5416 Rainier Avenue South

Design Review Packet / Land Use #3034508-LU / MUP Resubmittal #2 Date: 12.1.20

5416 Rainier Avenue South, Seattle, 98118 | Design Review Packet SDCI #3034508-LU

Design Precedent

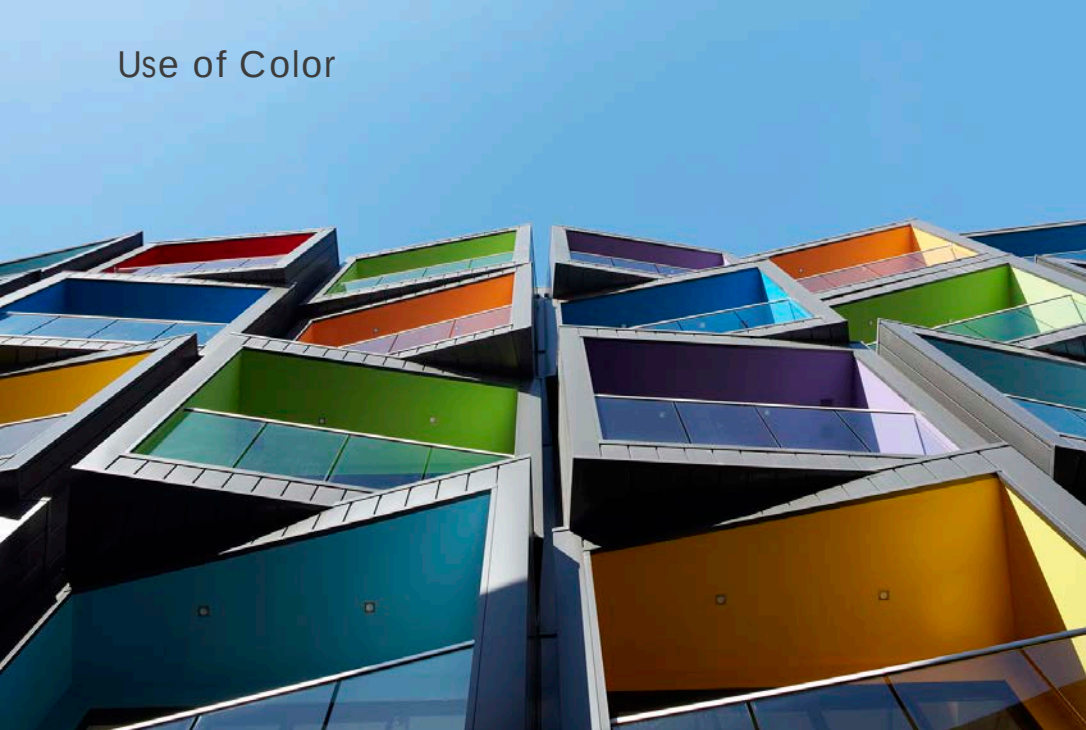
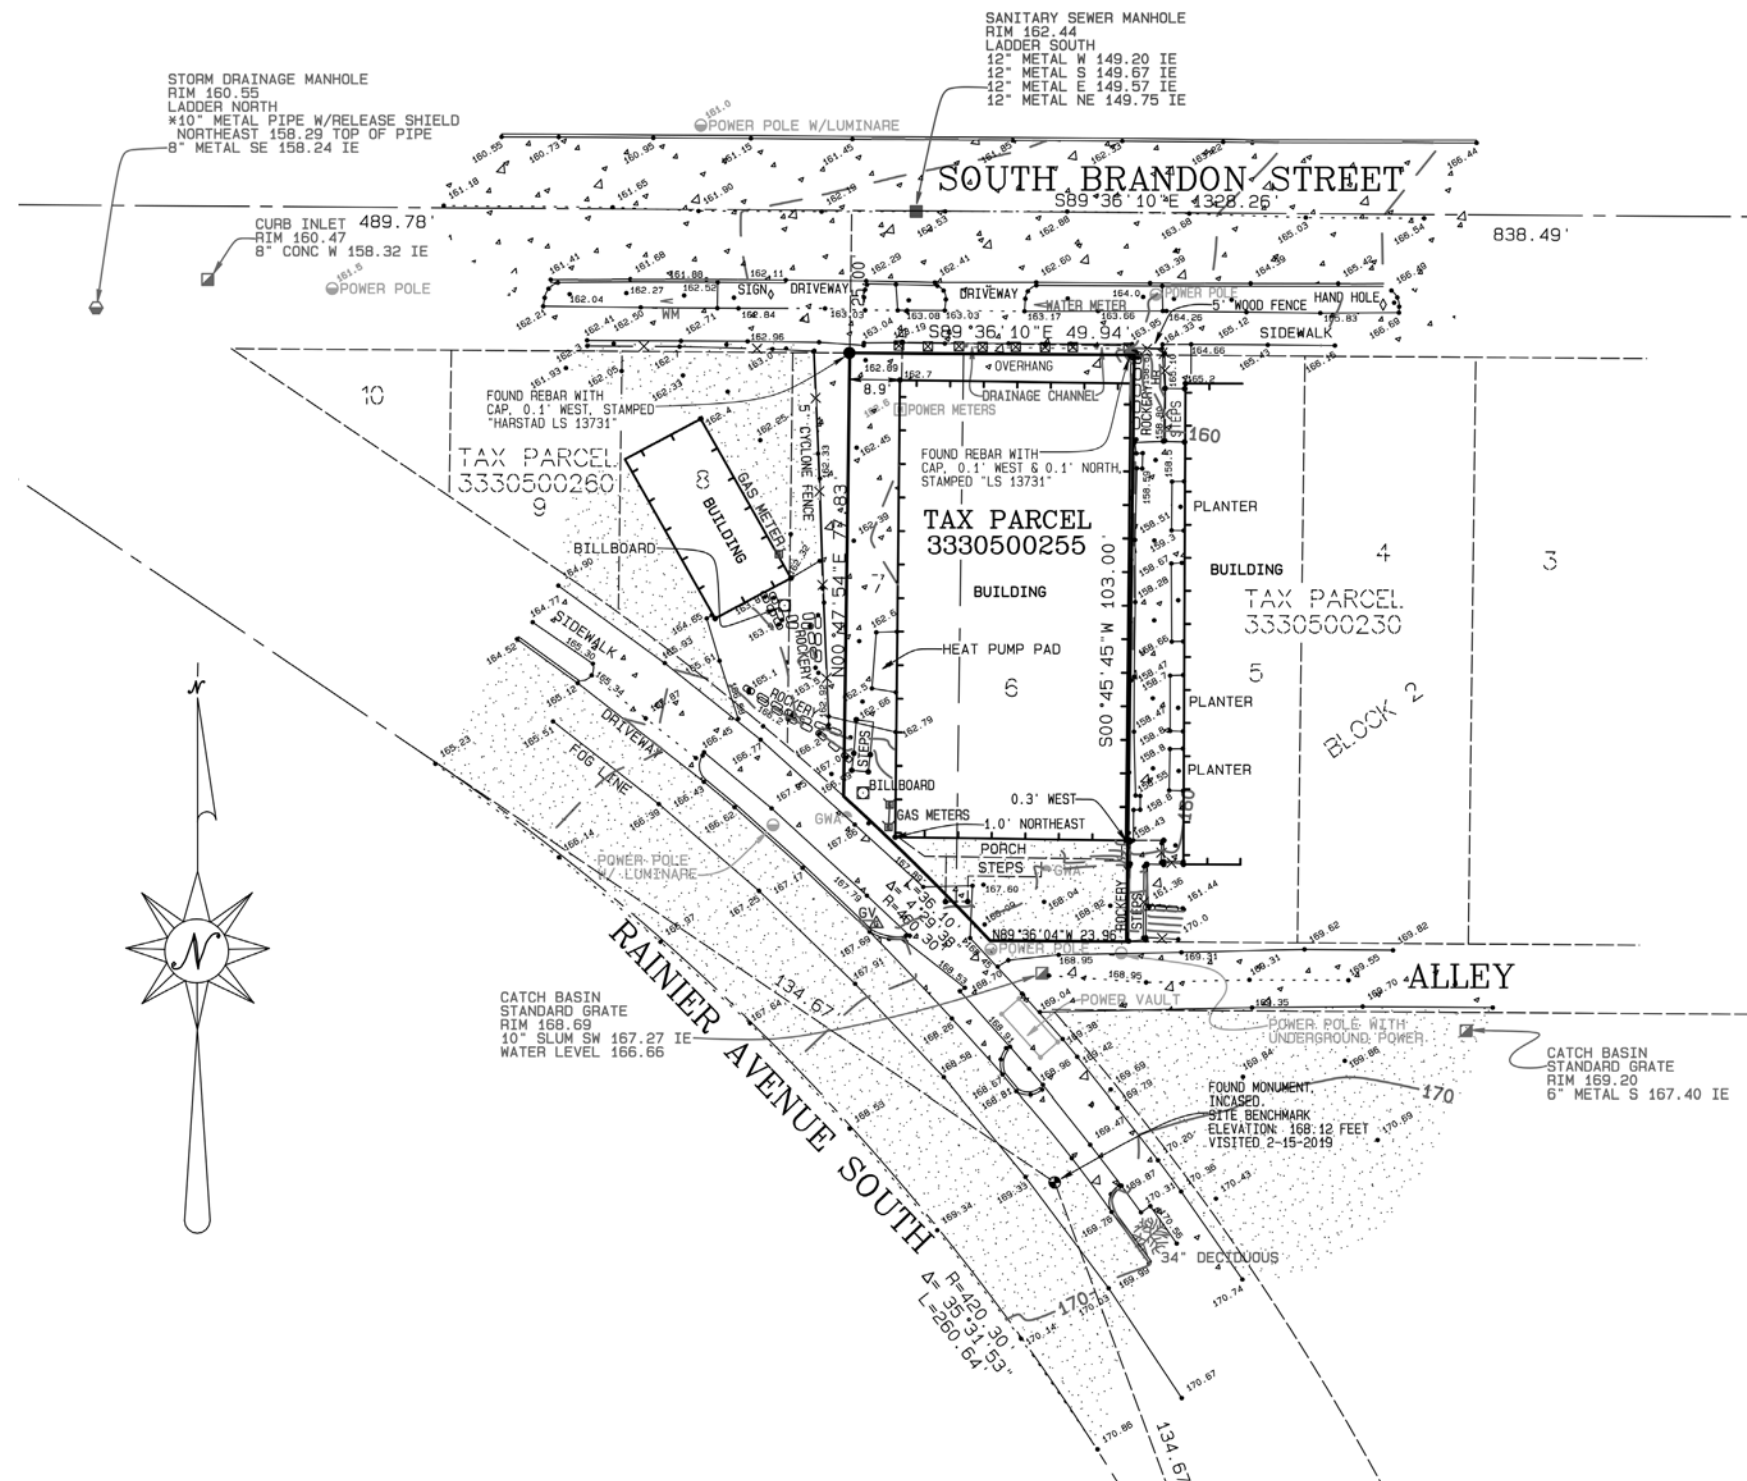
- b. The design precedent images on page nine of the EDG packet illustrate simple forms, use of color and art, and irregular geometry. The massing begins to echo these traits. With further development of the massing and architectural concept, design a compelling interpretation of these precedents.

Response: The site is naturally irregular helping to define the buildings shape. A mural is proposed along Rainier Avenue since fenestration is not an option due to building codes. Color is used on the private decks facing the residential neighborhood as well as the main canopy at the residential entry highlighting the residential use.
